<b>Case Numbers</b>	<b>P14-1033</b> (Design Review), <b>P14-1034</b> (Lot Line Adjustment)	
<b>Request</b>	To consider a Design Review of project plans for the construction of a 308,000 square foot industrial warehouse building and a Lot Line Adjustment to consolidate four parcels into one parcel.	
<b>Applicant</b>	Art Day of Transition Properties, L.P.	
<b>Project Location</b>	3705-3667 Placentia Lane, located on the south side of Center Street, north side of Placentia Lane, between Orange and Main Streets	
<b>APN</b>	246-070-002, 246-070-017, 246-040-027, 246-040-028	
<b>Project area</b>	15.9 acres	
<b>Ward</b>	1	
<b>Neighborhood</b>	Northside	
<b>General Plan Designation</b>	B/OP – Business/Office Park	
<b>Zoning Designation</b>	BMP – Business and Manufacturing Park Zone	
<b>Staff Planner</b>	Brian Norton, Senior Planner; 951-826-2308; <a href="mailto:bnorton@riversideca.gov">bnorton@riversideca.gov</a>

**CONDITIONS OF APPROVAL – Exhibit 1**

Case Numbers: **P14-1033** (Design Review)  
**P14-1034** (Lot Consolidation)

PRELIMINARY ELEVATIONS
------------------------

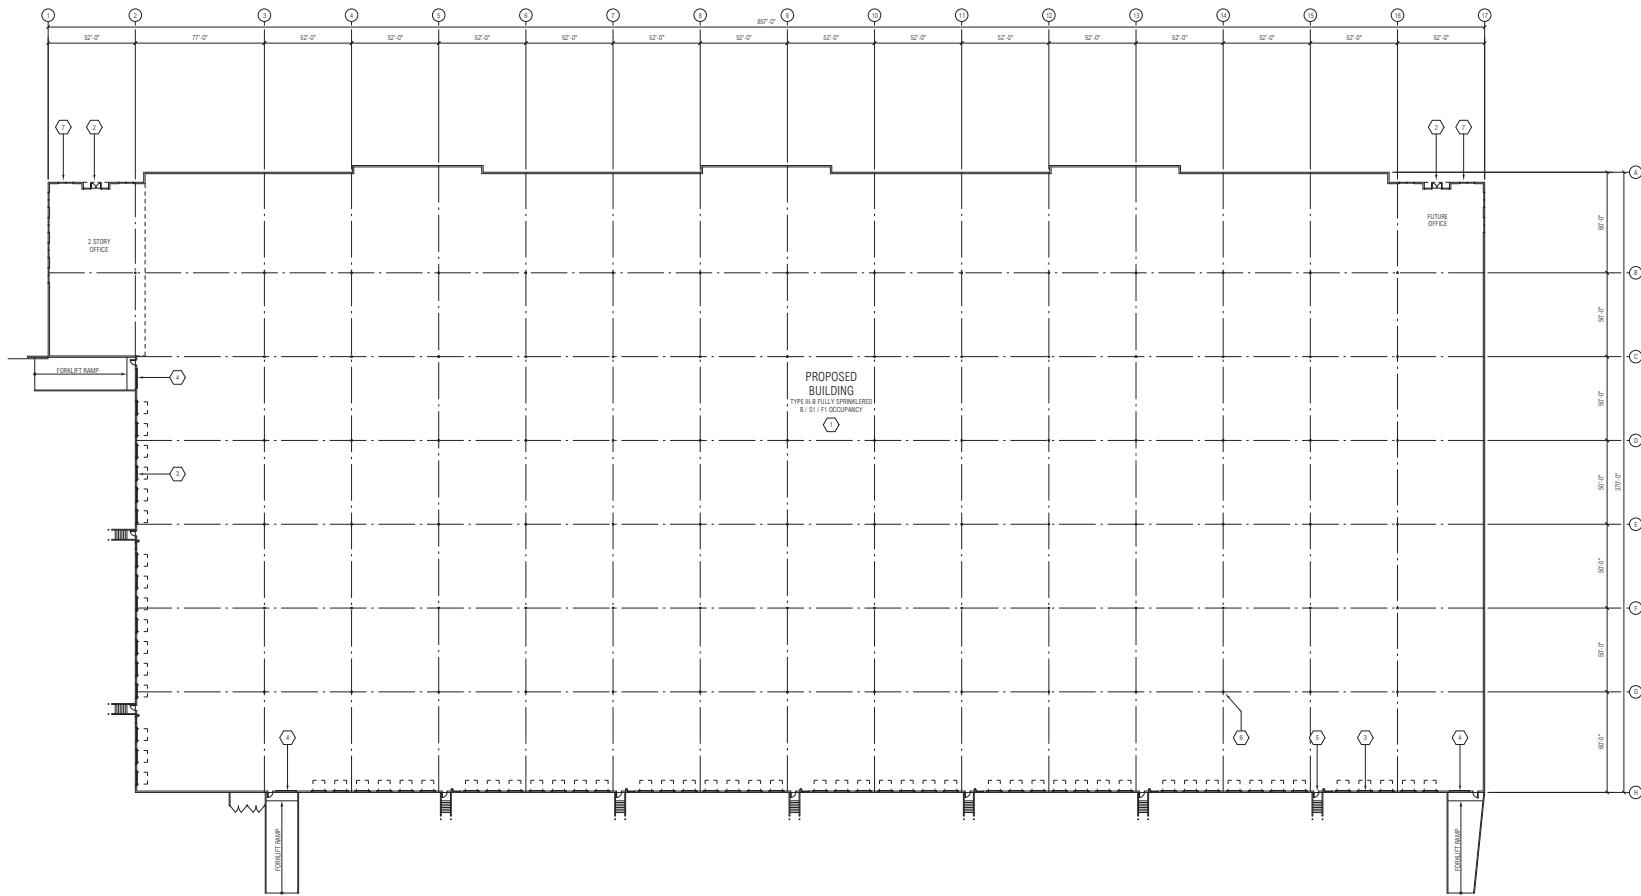
Staff has added conditions recommending 'returns' be added to office tower elements and panel sections that protrude higher than the main roof line adding visual interest and greater articulation. Additionally, staff recommends the westerly most south facing wall be enhanced and finished similar in architectural style to the office segments of the building. As conditioned, Staff supports the building elevations as they are consistent with recently constructed warehouse buildings located throughout the City and are consistent with the Citywide Design Guidelines.

19. **Staff Required Building Elevation Conditions:** Revise submitted building elevations such that the plans provided for building permit plan check incorporate the following changes:

- a. Where building walls protrude higher than the main roof line, returns shall be added.
  - b. The westerly most south facing wall be enhanced and finished similar in architectural style to the remainder of the building
